# E8364B-07A

## S E R V I C E N O T E

### E8364B PNA Series RF Network Analyzers

#### Add-on mechanical components to enhance instrument reliability

McMaster Carr item 6959A18 (T-10 torx size L-key)

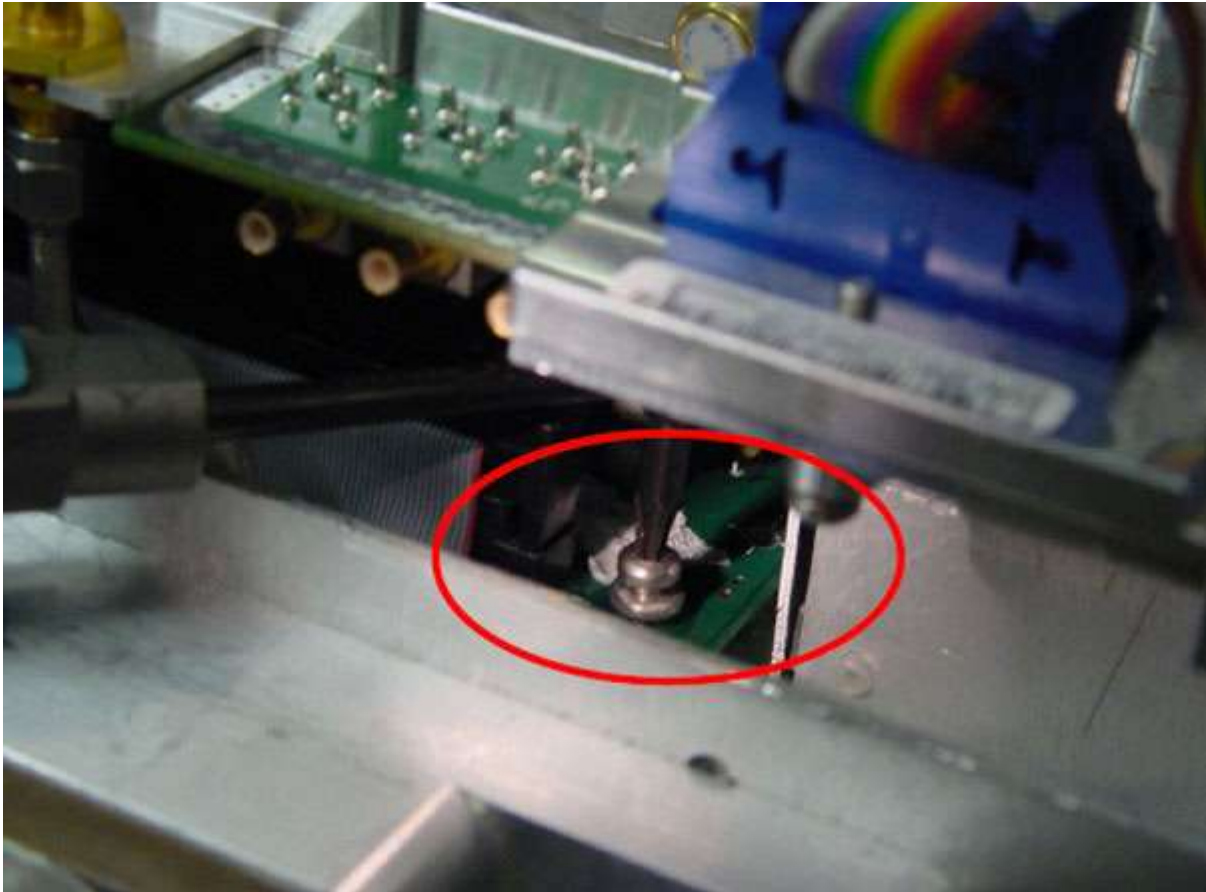
- b. Remove the open end head by loosening set screw. It will be replaced with L-Key shown below.

- c. Secure and orient the L-Key to the breakaway handle

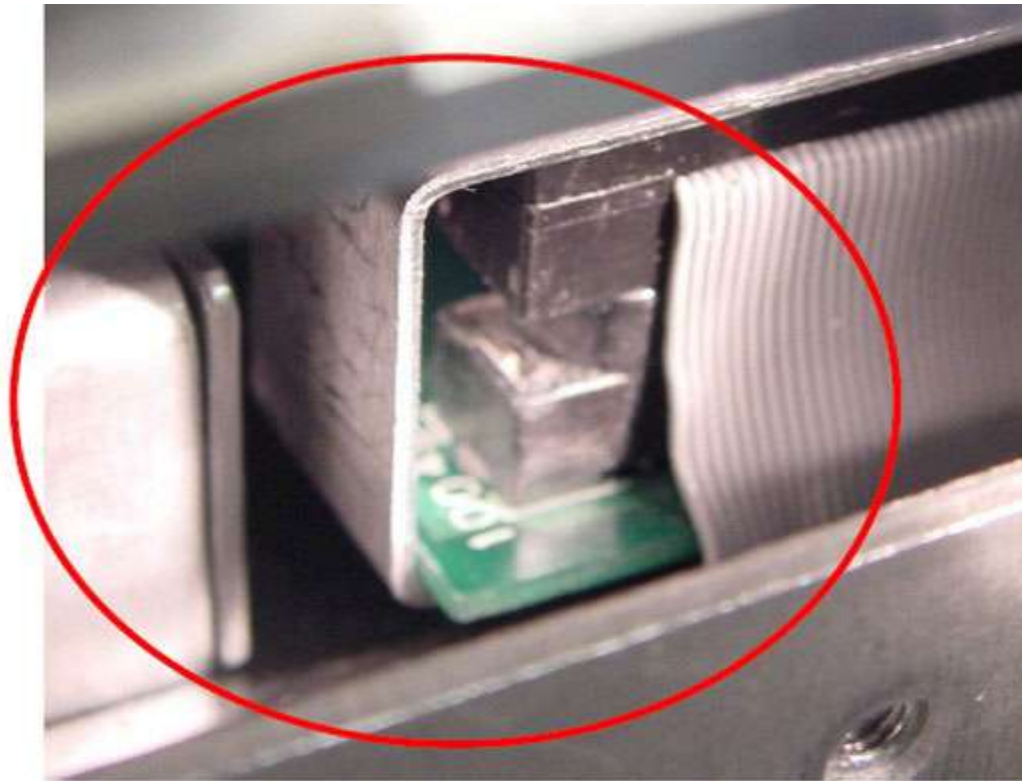
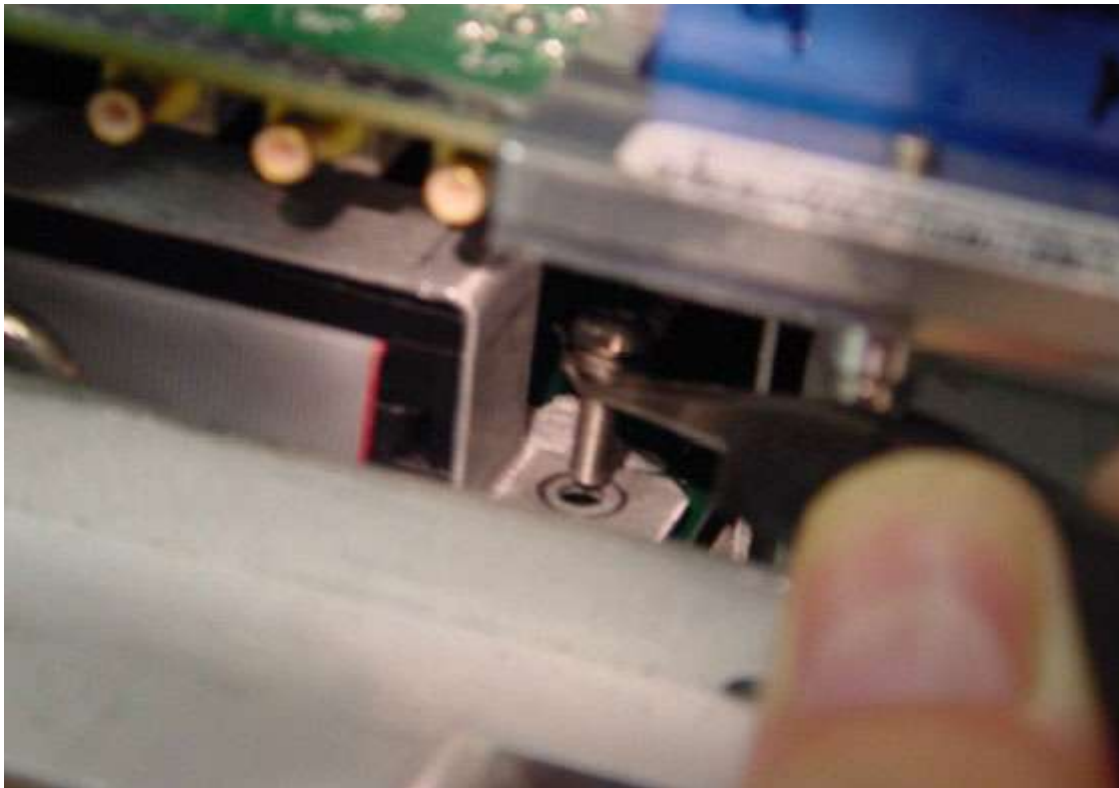
- a. Remove and discard existing screw near ribbon cable connector on System Motherboard. See below.

- b. Insert Ribbon Cable Clamp under Source Assembly as shown.

- c. Position the clamp over the Ribbon Connector. Use needle nose pliers if necessary to slide the clamp into place. Ensure that the edge of the clamp is parallel to the connector and not skewed.

**NOTE: Ensure that the Clamp Lip is secured BELOW the edge of the System Motherboard**

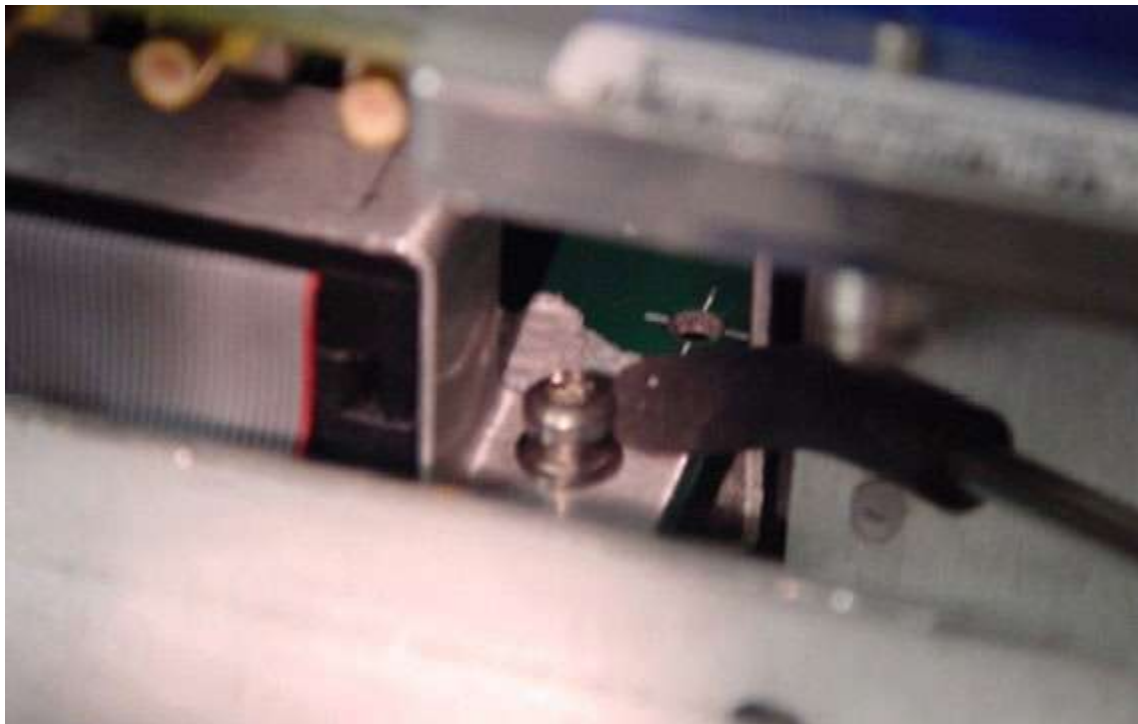
- d. Using tweezers, install a new 0515-0374 screw through the hole in the bracket.

Figure 2a

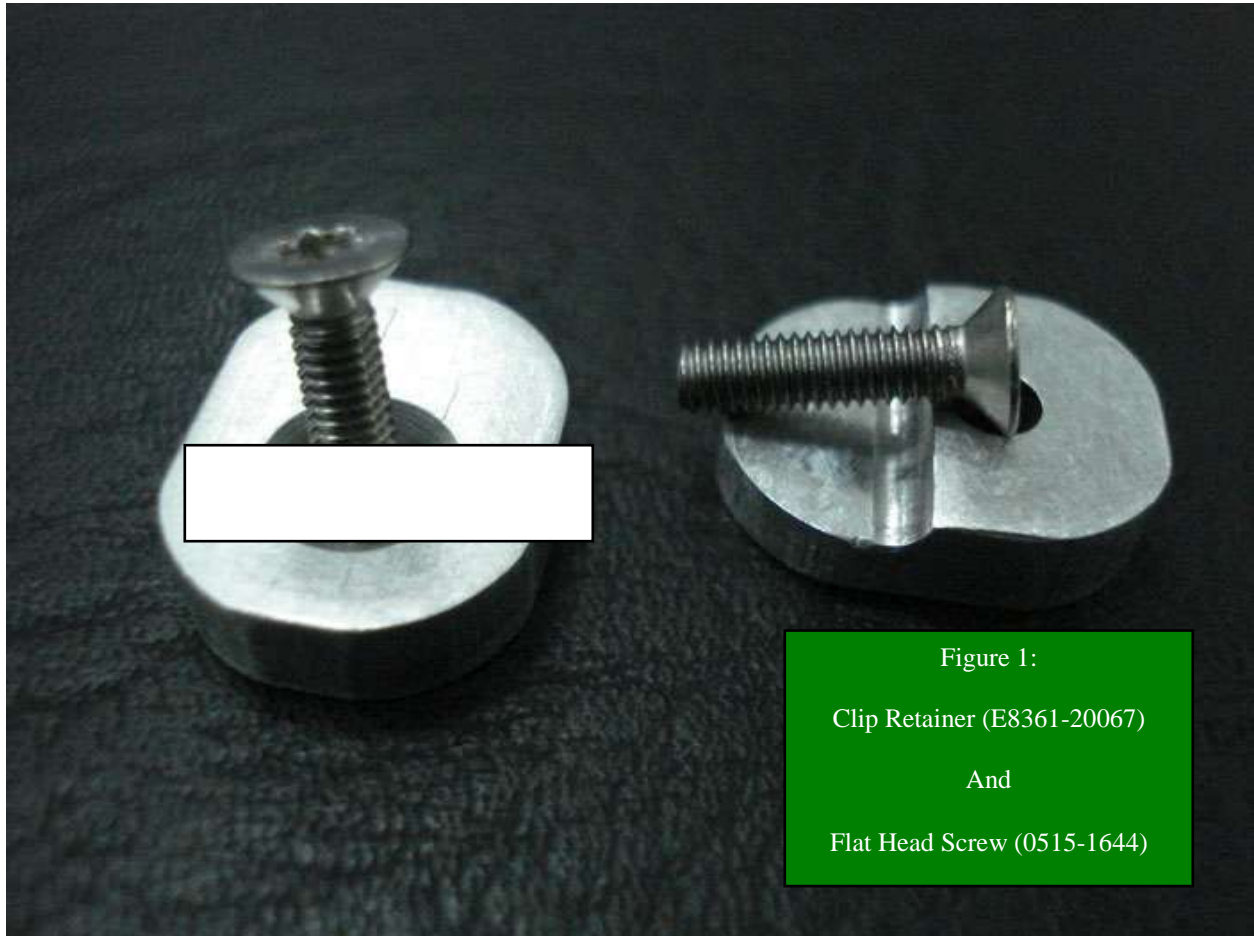
The Clip Retainer (E8361-20067) to be secured with Flat Head screw (0515-1644) in 2 places at 9 lb-in. This Retainer Clip may naturally rotate a bit when being secured, which is acceptable. Note that the existing screw needs to be removed and discarded prior installing Retainer Clip #1 (shown below in Figure 2a, 2b, and 3).
